UNITED STATES PATENT AND TRADEMARK OFFICE

10/625,495

Office Action Summary

DETAILED ACTION***Specification***

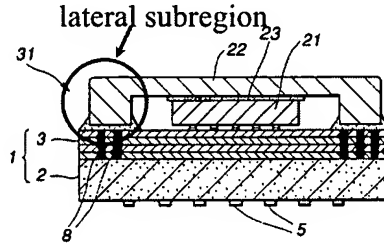
Regarding claim 1, Haimerl et al. teach a method for connecting an integrated circuit to a substrate, the method comprising:

providing a first electrical contact structure (Figs 20 and 21 (19 or 16), for example) on the integrated circuit;

providing a second electrical contact structure (12) on the substrate;

the second electrical contact structure having an elastic elevation (3) thereon (see abstract),

forming a current path (4, 1, 16 (in the alternative by bringing the first contact (16) into mechanical contact with the second contact (12))) between the first electrical contact structure and the second electrical contact structure; and

attaching the integrated circuit and the substrate, such that the elastic elevation is compressed.

Haimerl et al. do not teach attaching the integrated circuit to a frame structure or attaching the frame to the substrate. Imai teaches attaching a frame structure (22) to an integrated circuit (21) and attaching the frame to the substrate (1). It would have been obvious to one of ordinary skill in the art to incorporate the teaching of Imai into the method taught by Haimerl et al., since it is desirable to protect the IC, as well as provide a more secure connection to the substrate.

Regarding claim 2, Haimerl et al. do not teach a method, further comprising providing a lateral subregion in the frame structure, wherein the lateral subregion at least partially surrounds the IC. Imai teaches a method, further comprising providing a lateral subregion (See figure at right) in the frame structure, wherein the lateral subregion at least partially surrounds the IC (Col. 5, lines 58 – 60). It would
